MONROE COUNTY PLAN REVIEW COMMITTEE

A G E N D A
MONROE COUNTY PLAN REVIEW COMMITTEE

1. PUO-22-2

Wiley Farm at Fieldstone Tract F PUO

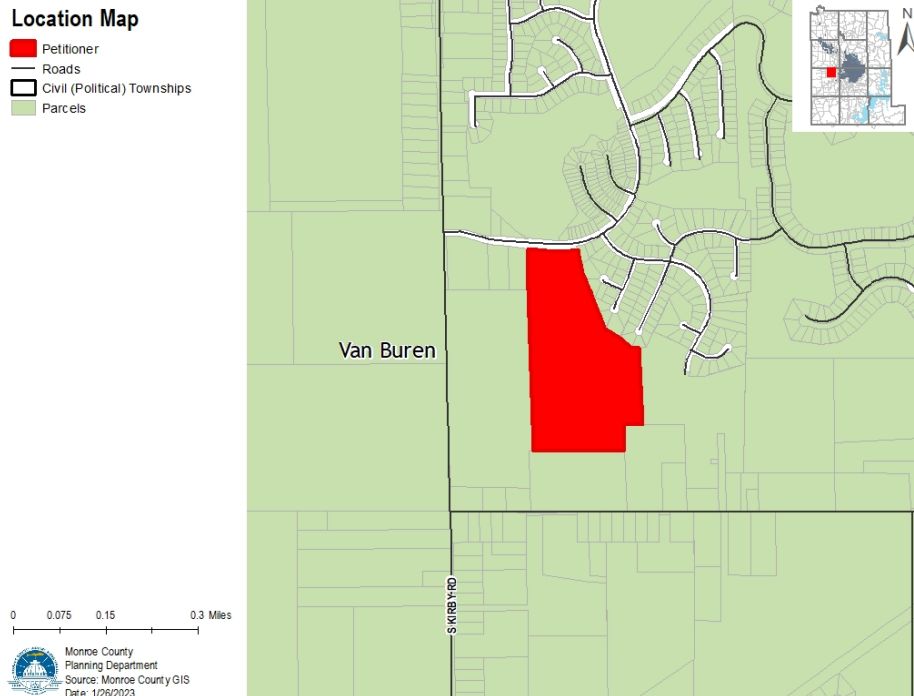
Hi Danny -

Based on our conversation, this is what we still need:

(b) Ownership: a statement of present and proposed ownership of all land within the project including the beneficial owners of a land trust?

- Get us confirmation from Bruce & Lana Conder that they consent to the new road changes.

(c) Development scheduling Parts 1 and 2

-State what the construction timeline would be (within 5 months of PUD approval)

(d) Proposed Uses: Include # of units per acre for each phase and include uses for the remainder.

- change the DU/acre to incorporate the change in remaining Multifamily acreage

Thank you Jackie.

Here are our responses to the last 3 items requested stated:

1. We had several meetings with the Condors over a six month time period to discuss a road option onto their property including, but not limited to, the following:

- Purchase of property to perform future road extension
- An easement from them to receive free infrastructure road extension.

The permission agreement at this time was to perform the Karst Study to determine possible routing through the property to avoid environmentally sensitive areas. The Condors and our client would like to hear more of the discussion with the Plan Commission and Commissioners on timing, requirements, etc. of this road extension before agreeing to anything concretely.

2. The desire is to start April 1, 2023 and finish for rental November, 2023

3. This proposal would use 3.97 acres of the 18.4 acres in tract 'F'. The PUD allows 10 units/acre. The remainder of tract 'F' would only allow for 144 units, not the 184.
